# APPENDIX K

## Individual Responses to Comments

### Individual Responses

#### **Letter 1 – Responses to Comments from Mojave Desert Air Quality Management District (MDAQMD)**

**Figure K-1**  
**Temporary Earthen Bridge Crossing Genesis Solar Energy**  
**Project's Engineered Flood Corridor, June, 2012**

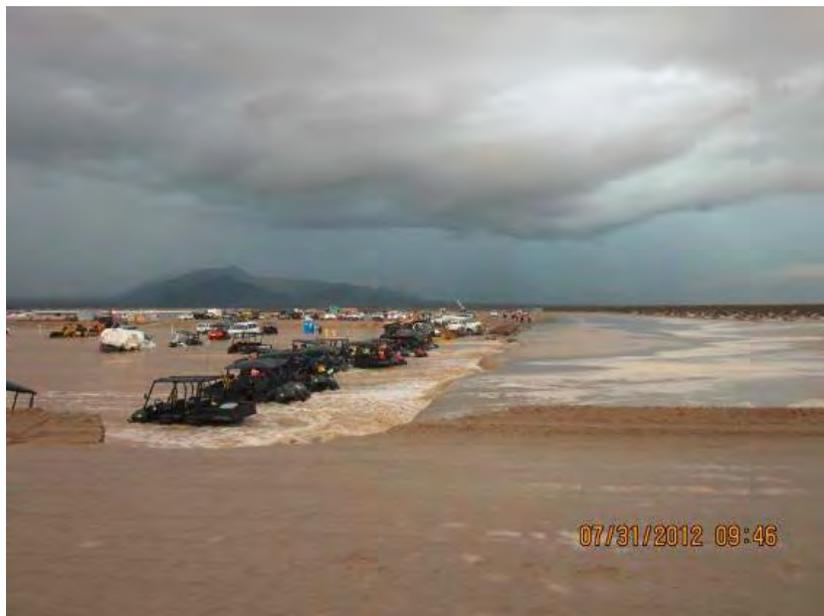
**Figure K-1.** As shown, the earthen bridge fills nearly the entire flood control channel. Relatively small pipe culverts can be noted at the foot of the earthen bridge, within the flood control channel. However, as shown, these were insufficiently sized to carry the full capacity of the flood control channel. When the July 30-31 storm event occurred, the earthen bridge was still in place and effectively prevented the flood control channel from conveying flood waters. As a result, flood waters backed up behind the bridge and then spilled over the existing flood control structure and onto the Genesis site. This is shown in **Figure K-2**. Other damage on site resulted from ditches that were not yet completed, underground piping filling with water, and the unfinished condition of one of the flood control channels. Direct damage to solar mirrors occurred as a result of wind damage.

The observed construction period failings at the Genesis site provide an interesting reference point with which to consider potential construction period flood impacts at other sites, including the Project. However, because the Project site employs a different flood management strategy from the Genesis project, the types of flood-related impacts that could occur during construction are different from those that occurred at the Genesis site. For example, the Project would not result in the concentration and conveyance of flows around the margins of the facility, and therefore there are no opportunities to interrupt such flows during the construction process. Instead, flows would fan across the surface of the site, and/or be conveyed in existing natural channels. Concentration of flows does, however, occur naturally in select locations on site, including along more defined channels that cross the site. During flood events, as discussed in Sections 3.20 and 4.20, these waterways could become inundated. It is not anticipated that construction activities would result in the construction of an earthen bridge or other structure in these areas that could restrict or reroute flood flows. Additionally, in areas where flood waters would fan out across the solar array installation area, structures such as elevated roads or other large elevated structures could interfere with flood flows, thereby concentrating flows and causing damage similar to that experienced at the Genesis site.

measures can be taken to reduce potential for flood related damage, in the event of a major storm event. For example, timing of the construction of select facilities, especially localized drainage features and features such as trenches and pipelines that could be inundated, should be managed so as to minimize potential for exposure to flooding, to the extent practicable.

As a result of these considerations, the PA/EIS has been updated to include additional discussion of potential construction period flood impacts, and implementation of mitigation that would minimize potential for construction period flood damage to occur on site. The following text has been added to Section 4.20.3.1:
